ZONING BOARD OF APPEALS

To: Zoning Board of Appeals Members
From: Adrianna Henriquez, Clerk
Date: 3/12/19
Subject: Materials for **March 27, 2019** Public Hearing

#02-19 Deborah Bing and Jonathan Hurwitz, 60 Crescent Avenue, Newton, Massachusetts, pursuant to M.G.L. c. 40A, § 8, and 15, appealing an interpretation by the Commissioner of Inspectional Services addressing the appellants' intent to construct a front porch located at 24 Moreland Avenue, Newton, Massachusetts. The subject property consists of a 7,092 square foot lot in a Single Residence (SR-2) district.

APPLICATION FOR ADMINISTRATIVE APPEAL

Exhibit A

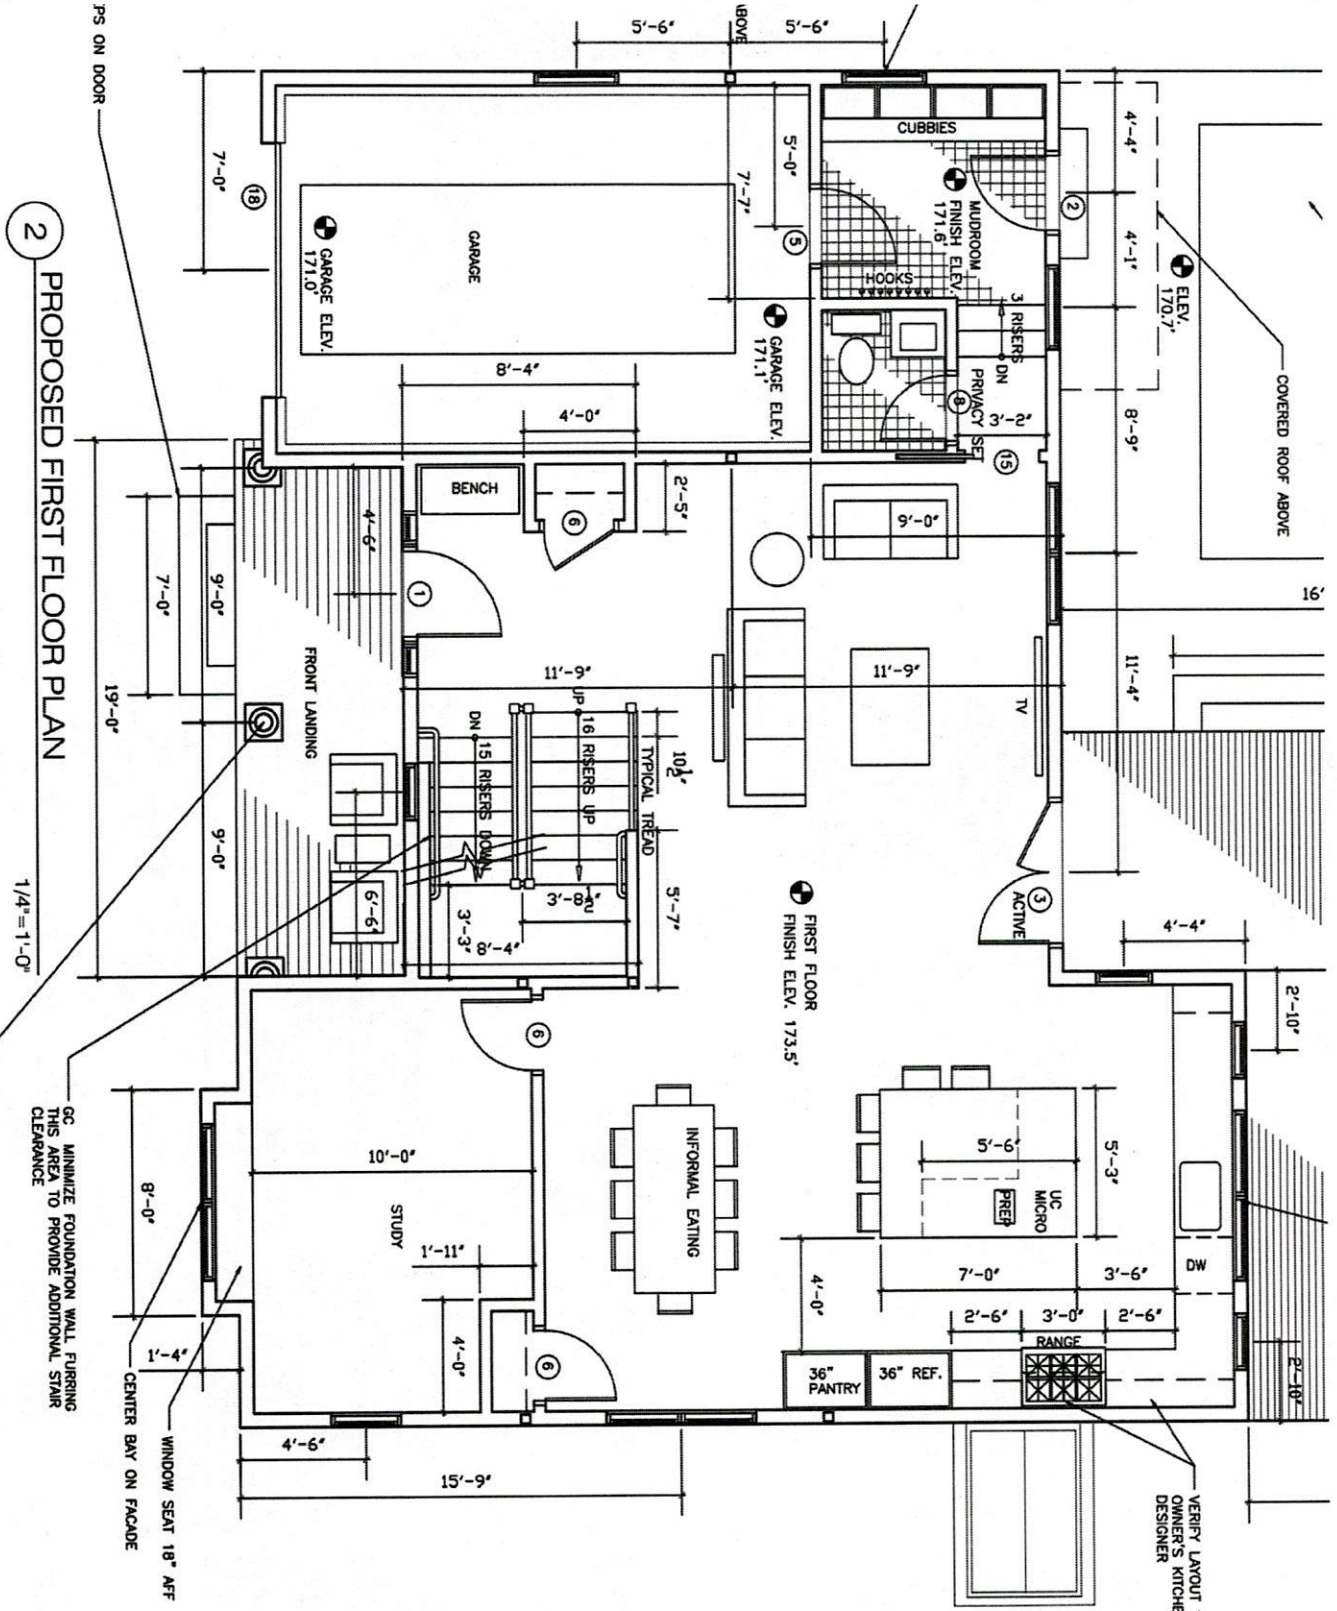
The design includes a covered entry that is unenclosed and facing the street. In my FAR calculations, I have not included the space as part of the square footage of the house since it unenclosed completely on the street side (not even railings). I wanted to make sure that it would not be interpreted as part of the house square footage for FAR purposes since it is recessed.

When our builder applied for our building permit in October 2018, Deputy Commissioner/Plans Examiner Anthony Ciccariello said that our unenclosed front porch *would* be counted towards the floor area of our property, which would bring us slightly over the permissible FAR. We believe that this is an incorrect interpretation of the Zoning Ordinance.

The design includes a covered entry that is unenclosed and facing the street. In my FAR calculations, I have not included the space as part of the square footage of the house since it unenclosed completely on the street side (not even railings). I wanted to make sure that it would not be interpreted as part of the house square footage for FAR purposes since it is excessive.

Ms. Santosuosso replied: "An open porch is not counted in the FAR. It should be fine." We moved forward with our plans. (See Exhibit B.)

An open porch is not counted in the FAR. It should be fine.

Exhibit C

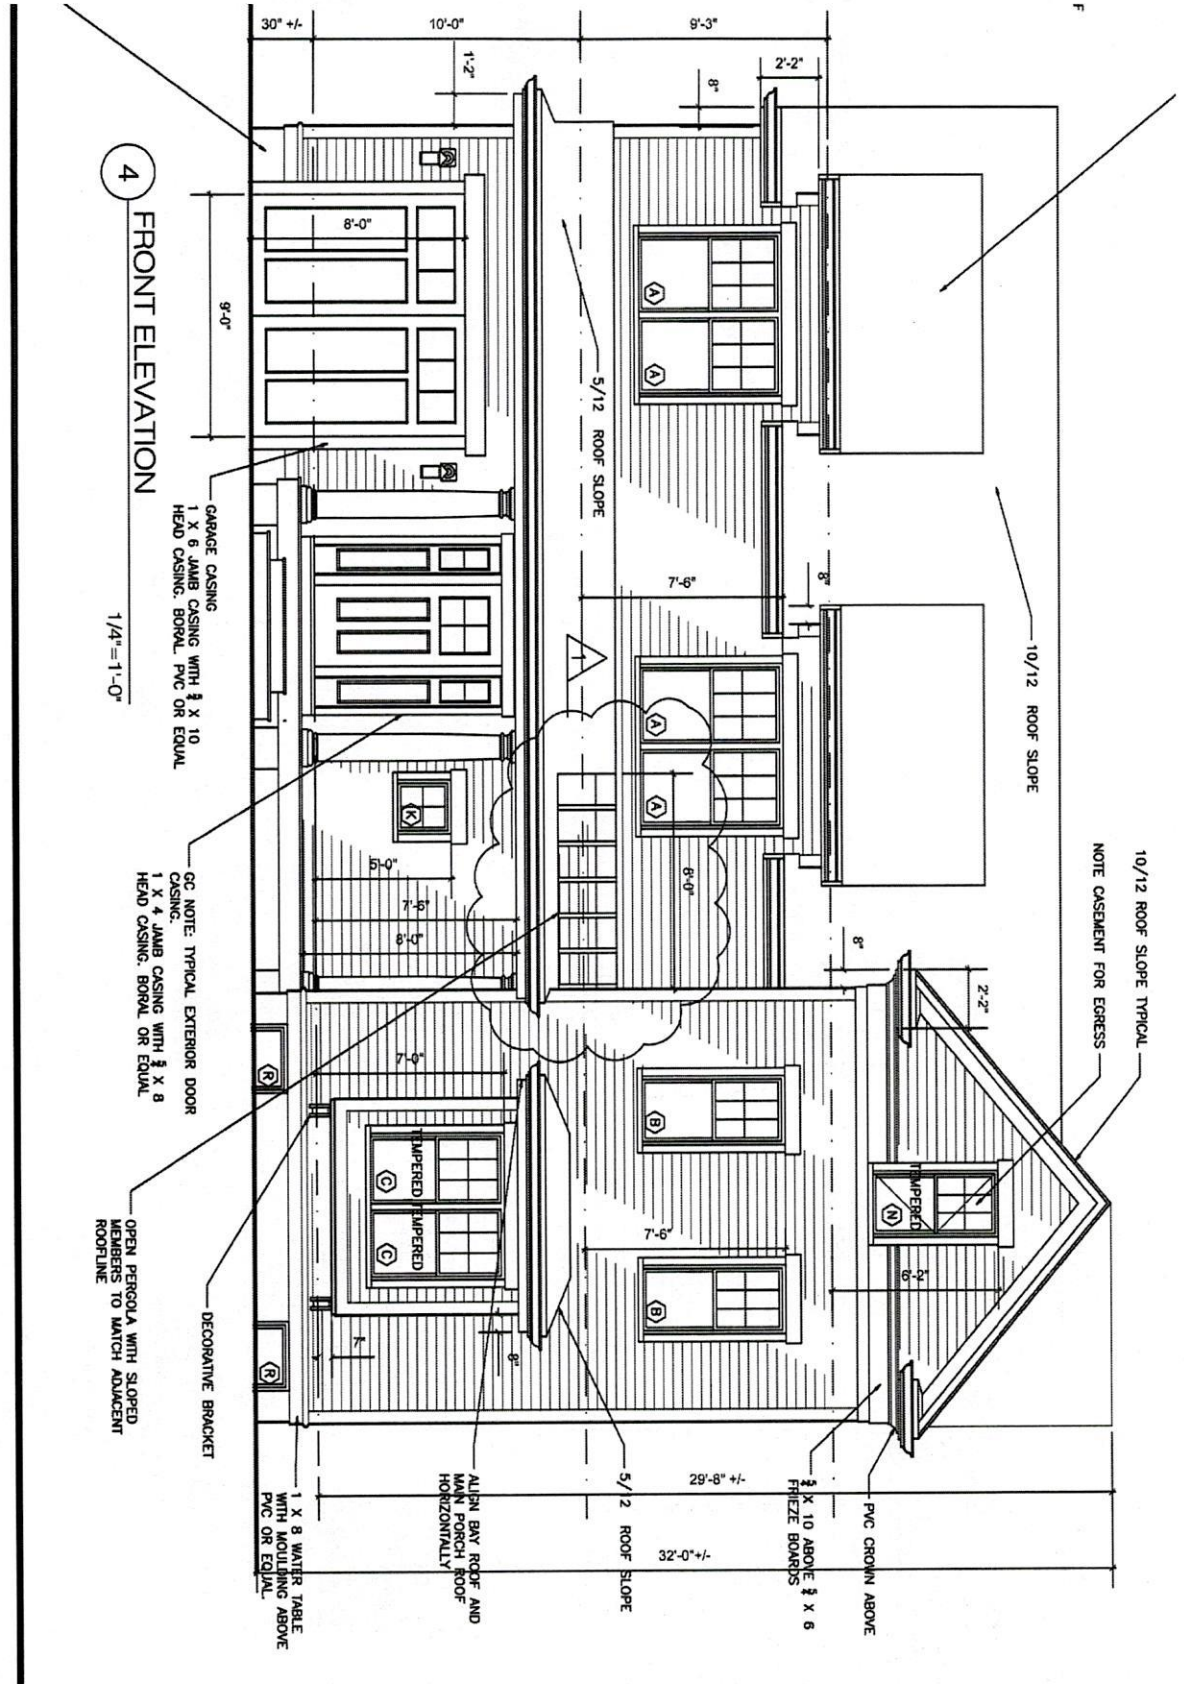
After a discussion with our architect, Mr. Ciccariello agreed to exclude the porch from floor area if we replaced a portion of the porch roof with an open pergola. Our plans were approved with that modification in November 2018. (See Exhibit C.) Since then, however, we have grown increasingly uncomfortable with this ungainly compromise.

OPEN PERGOLA WITH SLOPED
MEMBERS TO MATCH ADJACENT
ROOFLINE

The revised front exterior elevation with pergola,
as approved for construction by Inspectional Services.
